NORTH CENTRAL HIGH SCHOOL, PHASE 2

Addendum 4

FIELD LEVEL - AREA B
 SCALE: 1/8" = 1'-0"

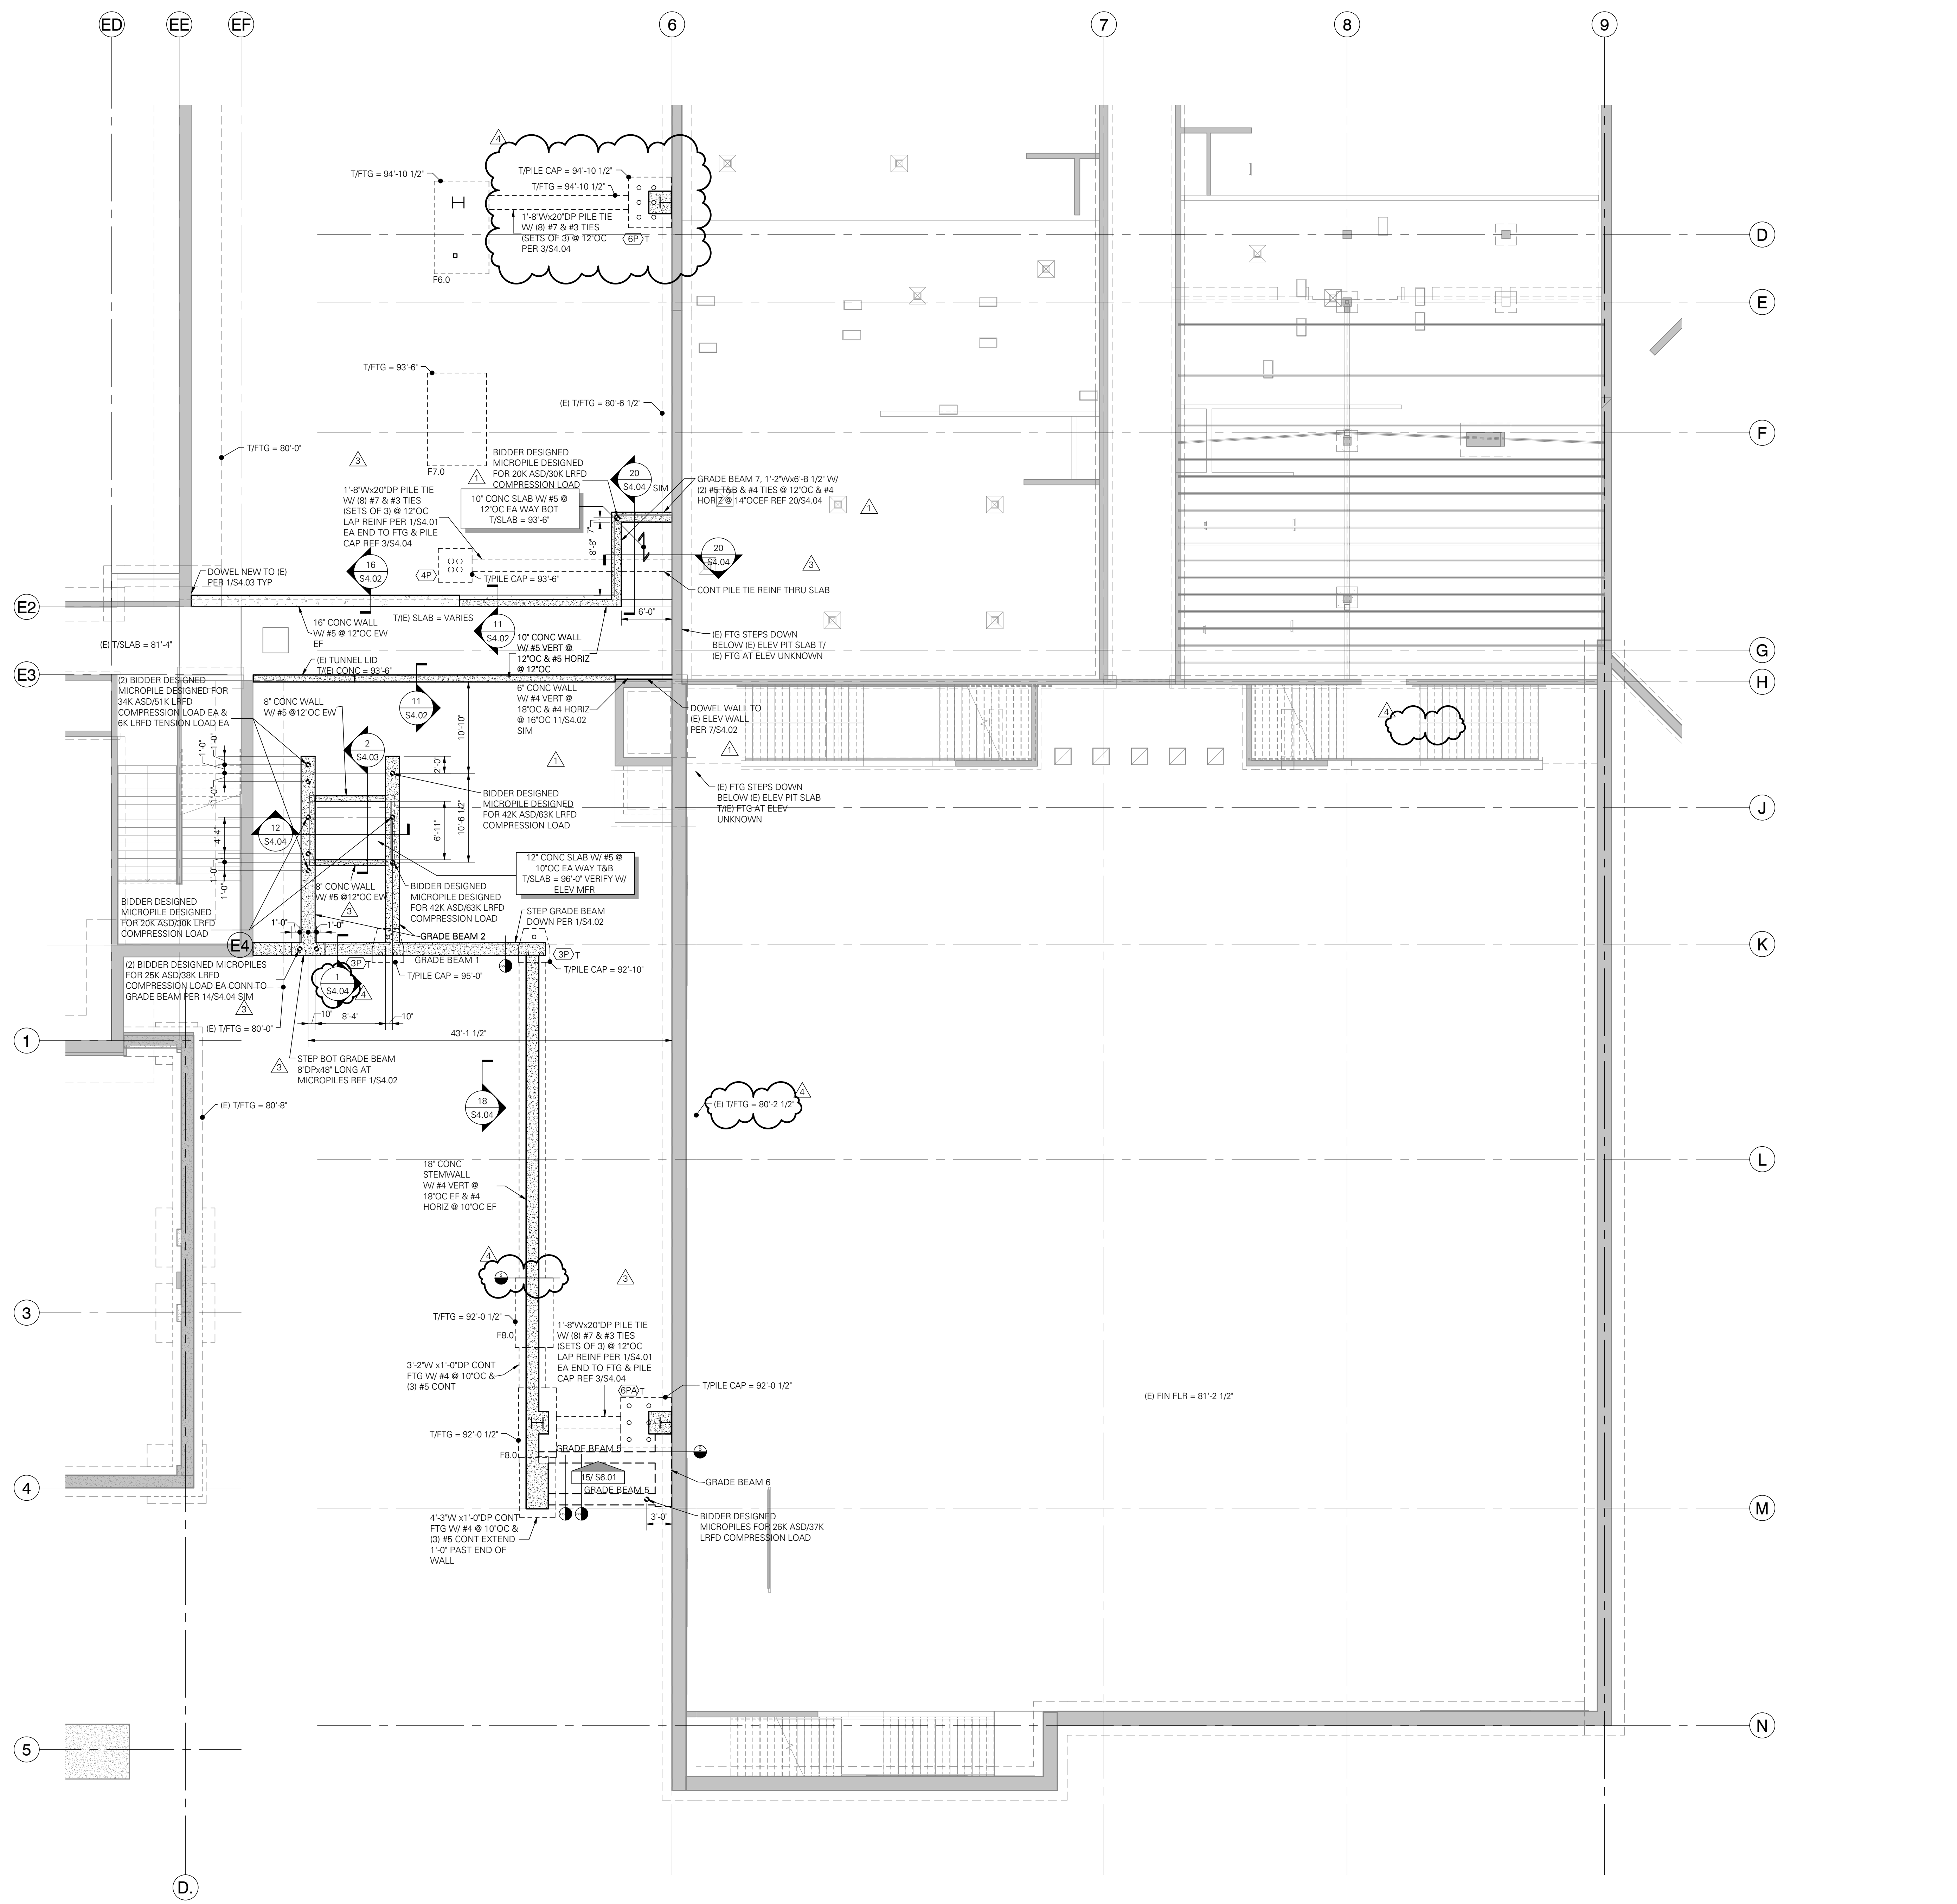
ADD: Detail reference 1/S4.04 along grid K between grids EF and 6.

12 MICROPILES AT EXISTING WALL
 SCALE: 1" = 1'-0"

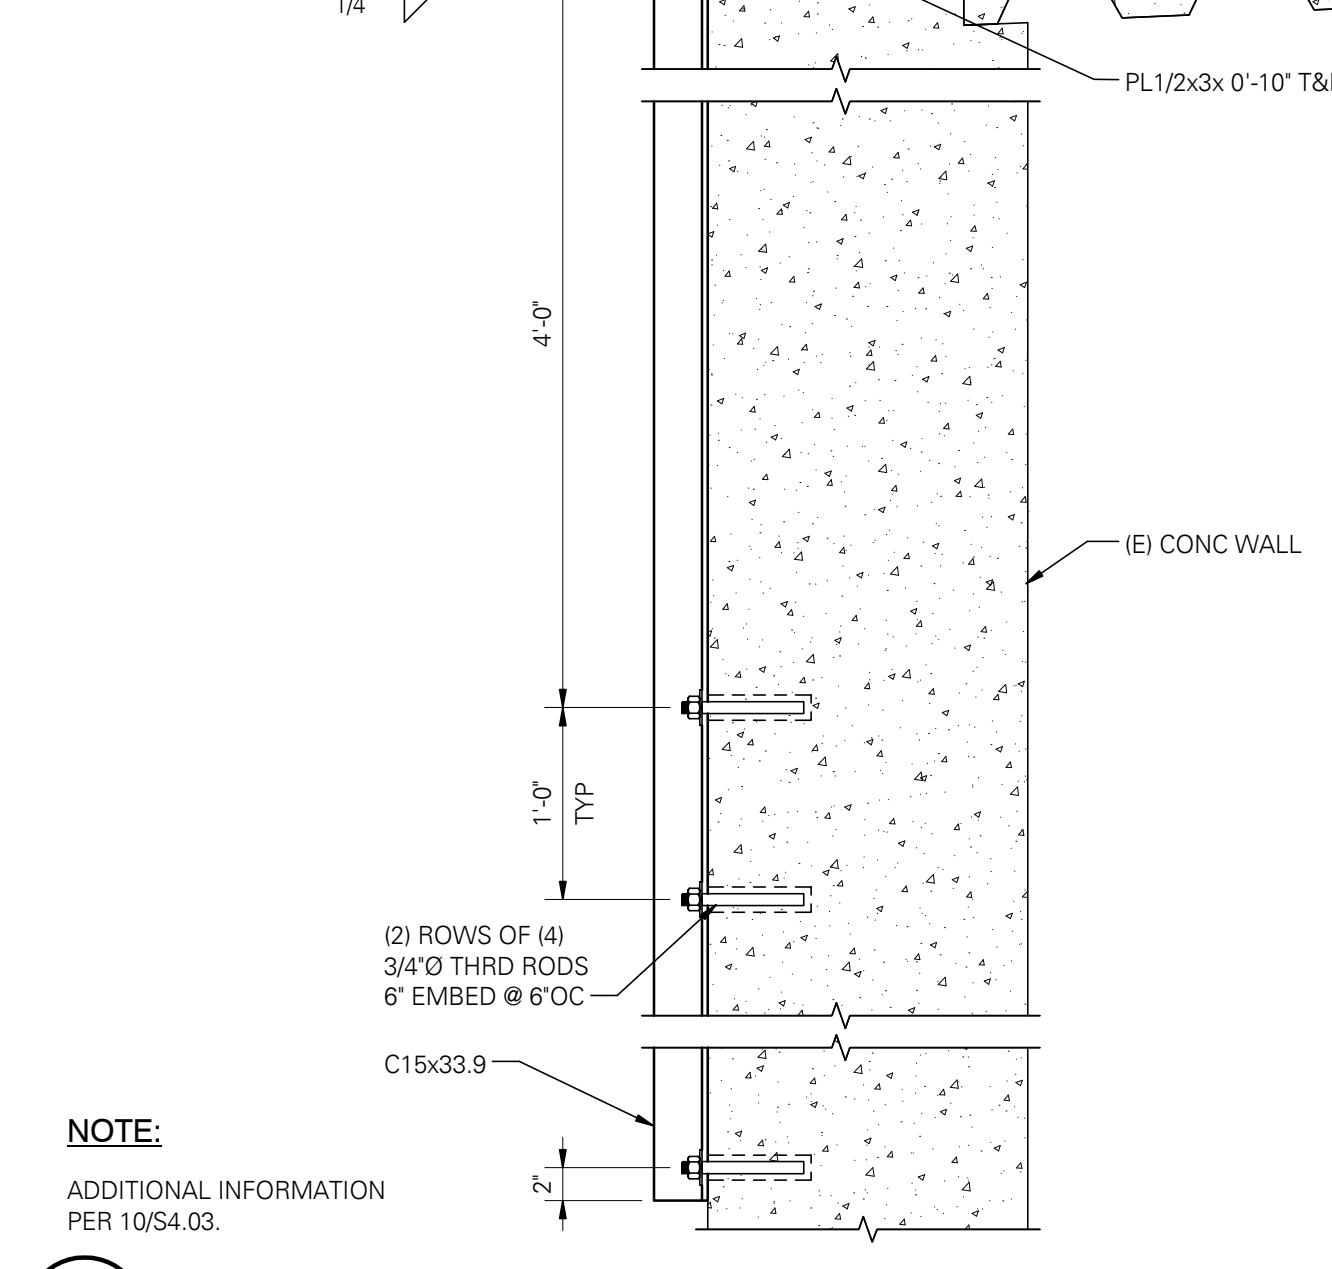
40 p. 6, after line 17, **Add:** "c. For horizontally installed micropiles on sheet S3.02 and detail 12/S4.03,
41 the no load zone is 8'-0" minimum beyond the inside face of the existing wall."
42

14 **REVISE:** Detail 12 in its entirety.
15

19 BRACED FRAME ELEVATION
SCALE: 1/8" = 1'-0"

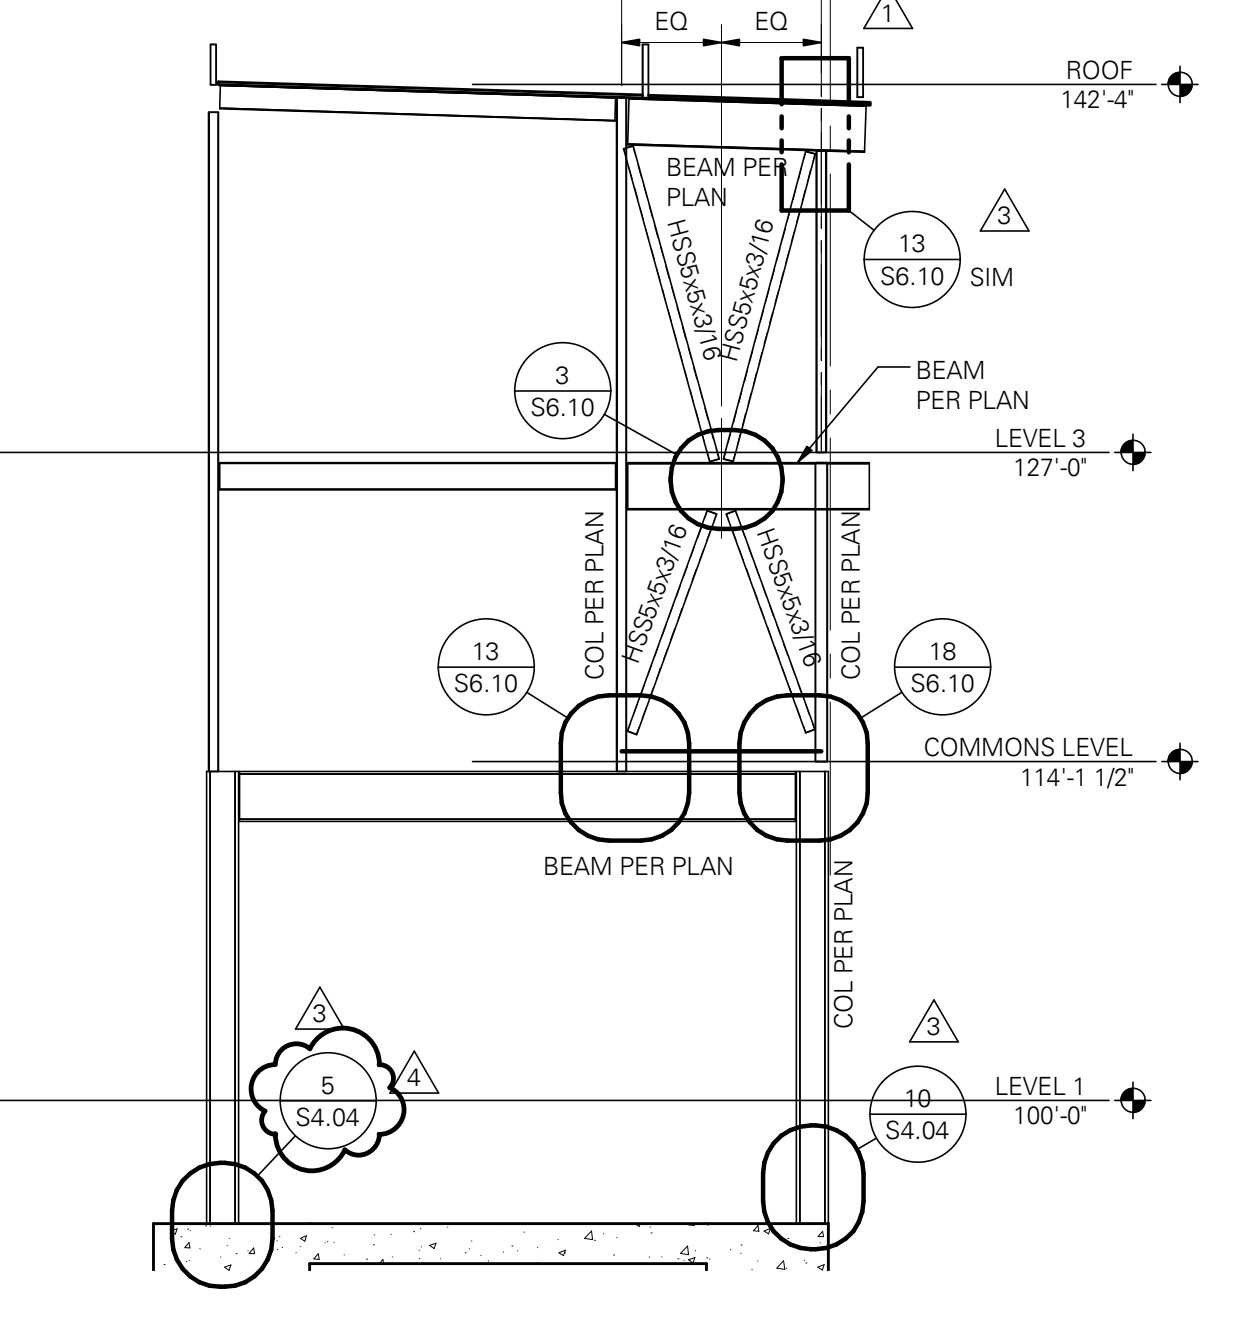
51 **REVISE:** Detail 15 AND 19. Revise the detail callout 15/S4.04 to 5/S4.04.
52
